In re: K246CL, Apple Valley, CA  
BPFT-20160729AAX  
Facility ID No. 156541

This refers to the above-captioned minor change application for K246CL.

Overlap attachment:

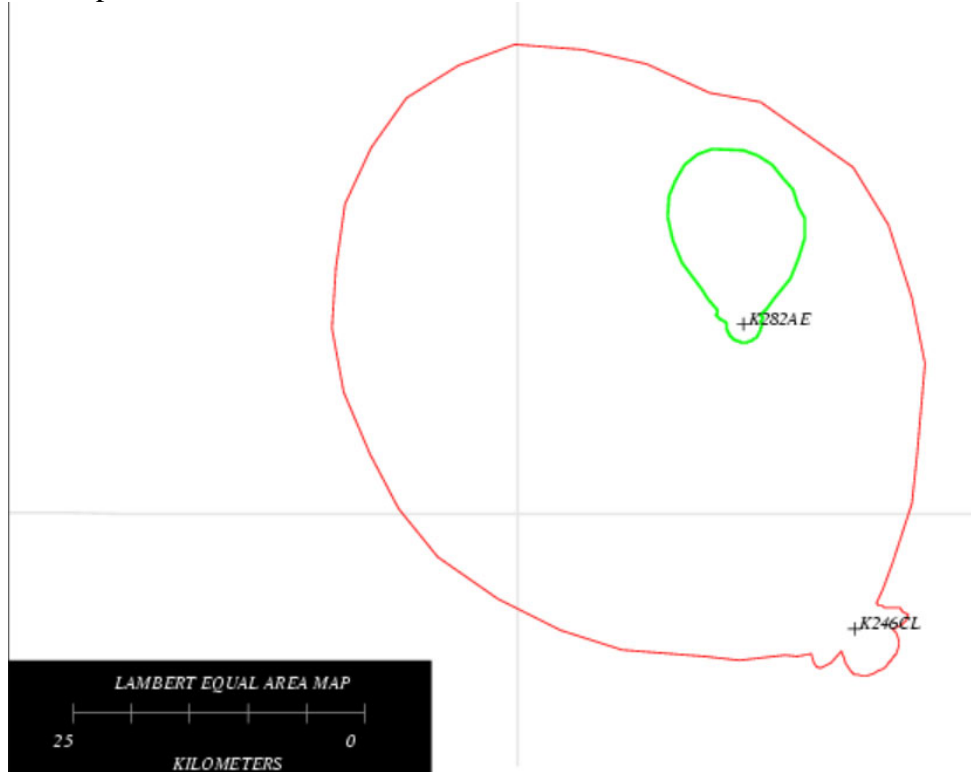
An engineering study reveals the application is in violation of the interference protection requirements of 47 C.F.R. Section 74.1204. Specifically, the proposed 40 dBu interfering contour overlaps the 60 dBu protected contour of the authorized facilities of co-channel translator station K300DC, Barstow, California (BPFT-20160728AHP). The application does not recognize this defect. Accordingly, we dismiss the application as unacceptable for filing.

Red contour: K246CL, BPFT-20160729AAX – 40 dBu interference contour  
Green contour: K300DC, BPFT-20160728AHP – 60 dBu protected contour

In light of the above, application BPFT-20160729AAX is unacceptable for filing pursuant to 47 C.F.R. § 73.3566(a) and IS HEREBY DISMISSED. This action is taken pursuant to 47 C.F.R. § 0.283.
